24 CFR Part 3280

[Docket No. FR-5222-F-02]

Manufactured Home Construction and Safety Standards, Test Procedures for Roof Trusses

ACTION: Final rule.

Figure 3280.402(b)(1) – Test fixture for testing trusses singly

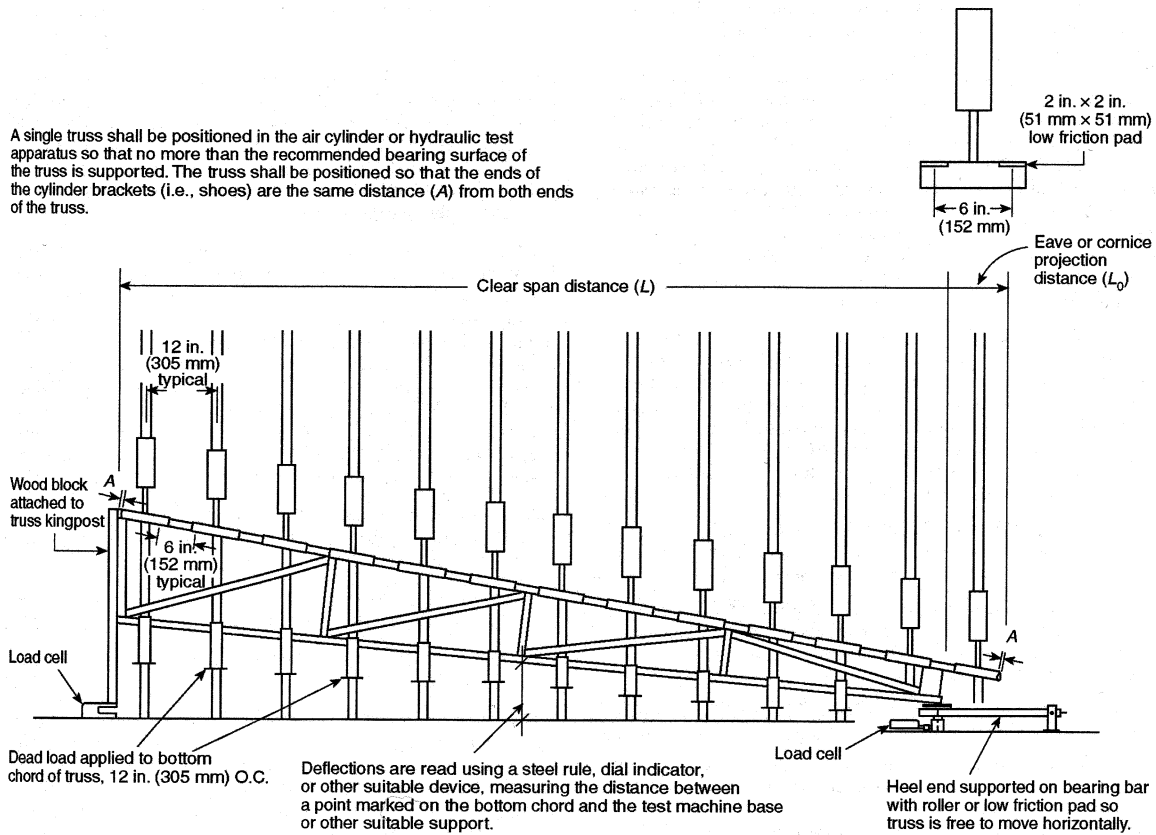
Question 2: Should the spacing between hydraulic or pneumatic cylinders for the test fixture be increased from 12 inches to 24 inches in Figures 3280.402(b)(1) and 3280.402(b)(3)? Should the distance between friction pads along the top chord of the truss of the test fixture be increased from 6 inches to 12 inches in Figure 3280.402(b)(1)? Should the distance between 1-inch straps attached around the cylinder shoe and the top chord of the truss of the test fixture be increased from 6 inches to 12 inches in Figure 3280.402(b)(3)?

Comment. The commenters indicated that the loading cylinders should be maintained at 12 inches and that the loading shoes should be 6 inches long with loading pads at each end to provide a more realistic simulation of a uniformly distributed loading upon the truss.

HUD Response: HUD agrees with the commenters that the cylinders spacing needs to be maintained at 12 inches to more closely simulate uniform loading of the truss, and the loading shoes need to be 6 inches long with loading pads at each end, and has specified these requirements in the final rule.
